ISSUED 2000-08 REVISED 2006-05

SCREW, MACHINE - DOUBLE HEXAGON EXTENDED WASHER HEAD, CORROSION AND HEAT RESISTANT STEEL, UNS S66286, 130 KSI MIN, .1640-36 UNJF-3A

AS9555
SHEET 1 OF 2

REV. B

FIGURE 1 - SCREW

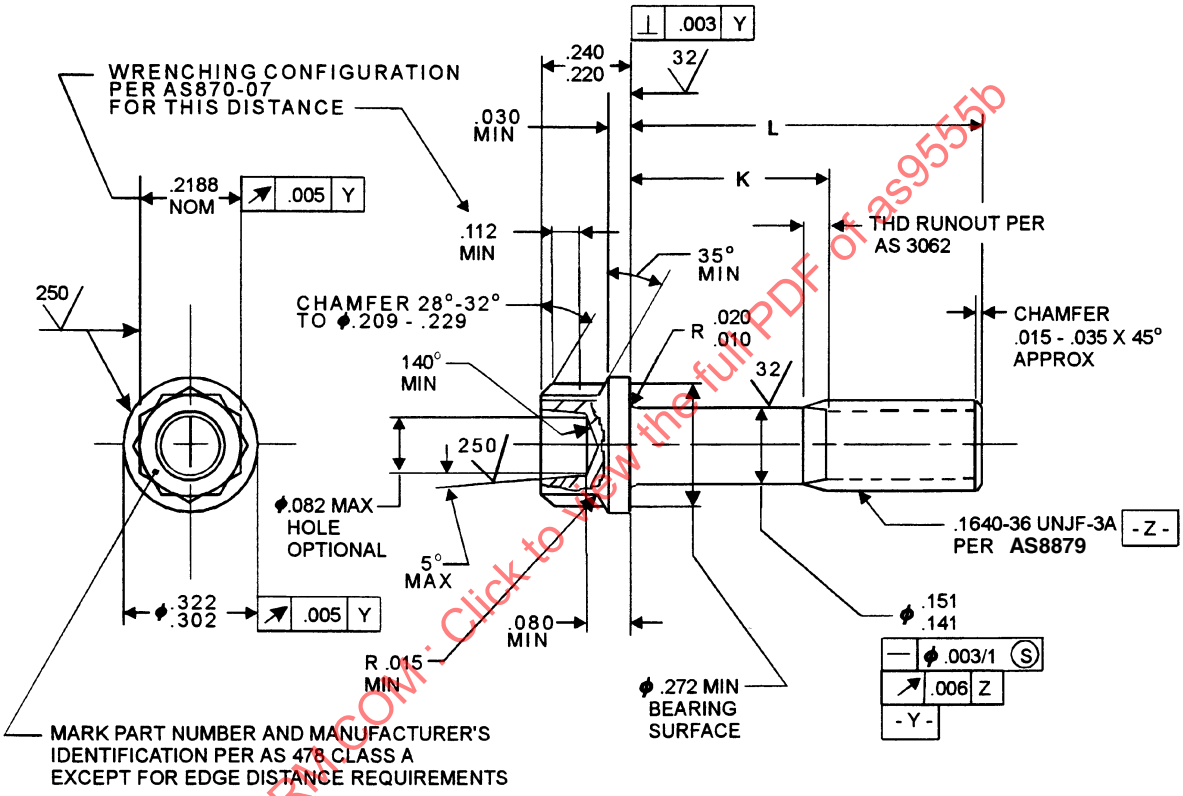
ADD DATUM REQUIREMENTS FOR -02 THRU -12 LENGTHS (NEW NOTE 1) AND REVISE THREAD SPEC TO AS8879.
